BRIEFING

This company was instructed by Mr [REDACTED] of [REDACTED], to inspect and report on the roofing and cladding for a new [REDACTED], [REDACTED] Retail Park [REDACTED], Haverhill.

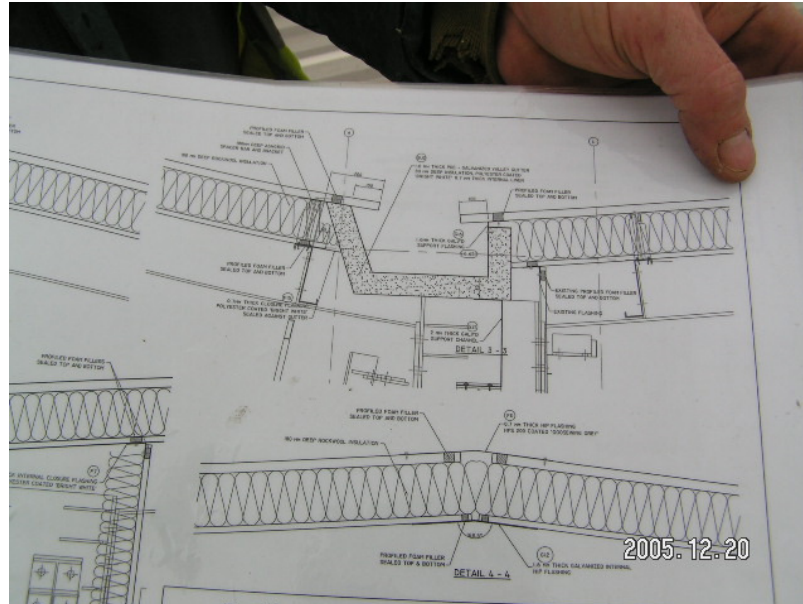
- 1) Some of the ashgrid were facing in the wrong direction. The contractor should satisfy himself that this has no detrimental effect on the roof integrity or compromises the non-fragile status that is being sought.

Similarly the ashgrid spacer was omitted at rooflights. The same request as above applies

The manufacturer's drop test papers should be obtained and the contractor should ensure that compliance is being obtained.
